## Safety notice UP 2019-01

**Subject:** Trim of Ascent 4 and Mana

### Concerned products: Ascent 4 and Mana

**If the total flight hours of your glider are less than 20 hours: AI, AII and BI, BII - Lines each need a trim loop (picture symbolic before - after)**

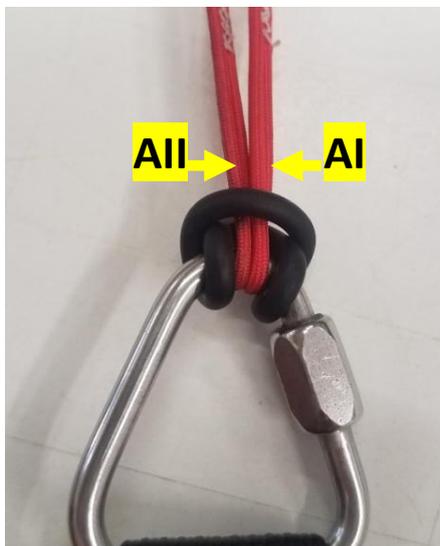
On few Ascent 4 the glider went into a condition similar to deep stall after big ears maneuver was carried out (high sink rate also after releasing ears), or when brakes were pulled too far on slow speed a deep stall tendency was determined. Most of these incidents have occurred with gliders flown at low to medium take-off weights. None of these incidents have led to an accident, however, as a precaution; this safety notice must be implemented immediately.

The inevitable length change of the lines by stretching (A and B level) or shrinkage (C level) after the first flights can normally be remedied by opening the trim loops on the C lines after about 20 flight hours. However, the stretch of the lines at the A and B level after the first

flights on these models is slightly stronger than expected and can thus lead to the mentioned problems.

0 Trimloops

1 Trimloop

**AI, II – Left Riser (Right riser similar): Loops before and after the measure**

**Before:** AI and AII line have 0 trim loops

**After:** 1 trim loop on AI and AII
